MFN 06-466 Supplement 1

**Subject: Response to Portion of NRC Request for Additional Information
Letter No. 79 - Passive Containment Cooling System - RAI Number
6.2-102 S01**

RAI Number 6.2-102 S01

Figure 2.15.4-1. Passive Containment Cooling System Schematic

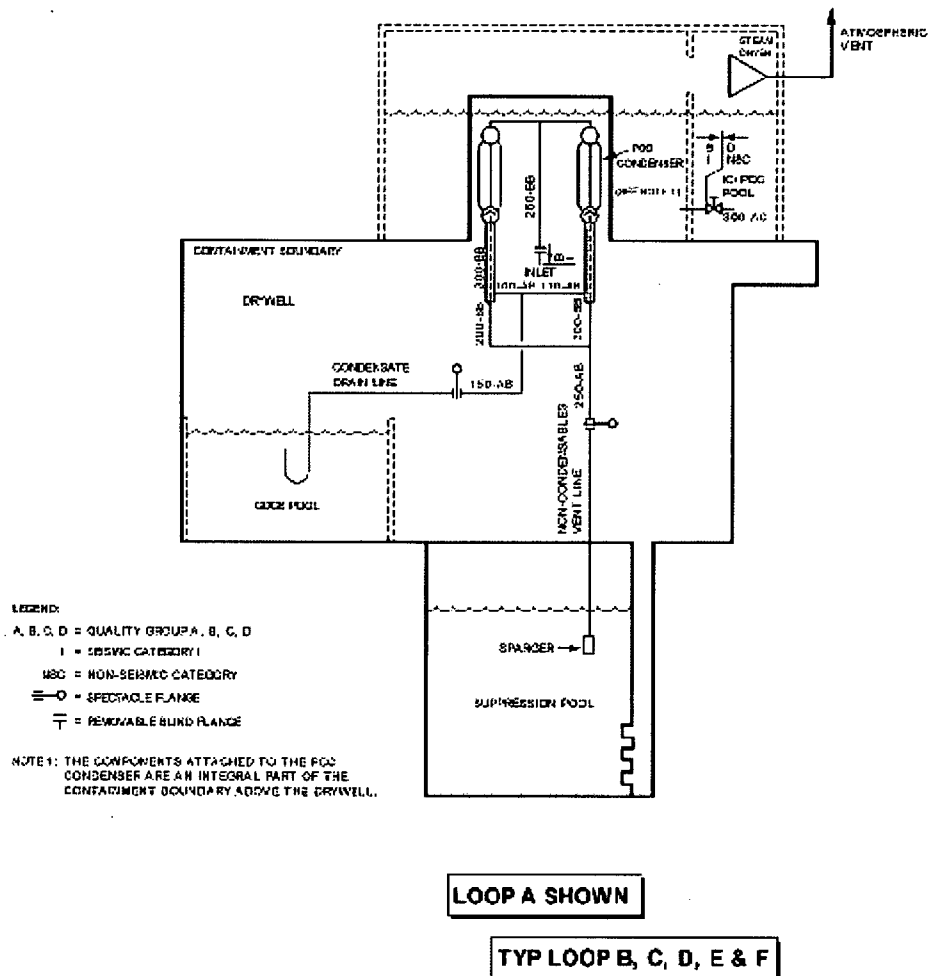
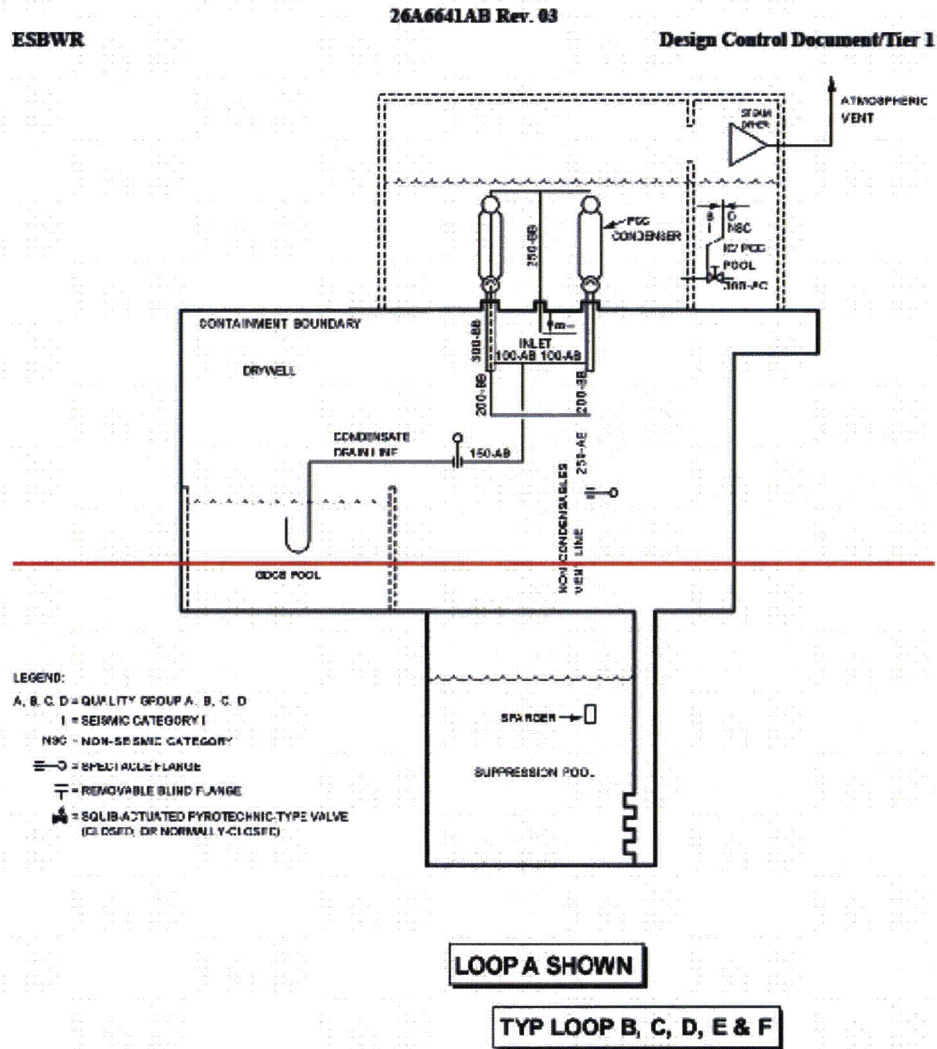
Provide additional justification for the current design of the PCCS, or revise the DCD with a redesign of the system to include CIVs, per the NRC's applicable regulatory position.

- Tier 1, Subsection 2.15.4
- Tier 1, Table 2.15.4-1
- Tier 1, Figure 2.15.4-1
- Tier 2, Figure 1.1-2
- Tier 2, Subsection 1.2.2.15.4
- Tier 2, Table 1.3-2
- Tier 2, Sections 3.1 and 3.8
- Tier 2, Table 3.2-1
- Tier 2, Subsection 3.9.3
- Tier 2, Section 6.2 and Subsection 6.6.1
- Tier 2, Tables 6.2-10 and 6.2-47
- Tier 2, Figures 6.2-1, 6.2-15, and 6.2-16
- Tier 2, Subsections 7.1.5 and 7.3.2
- Tier 2, Subsections 9.1.6 and 9.2.5
- Tier 2, Subsection 15.5.6
- Tier 2, Subsection 16.3.6.1.7, 16B.3.6.1.7, and 16B.3.7.1
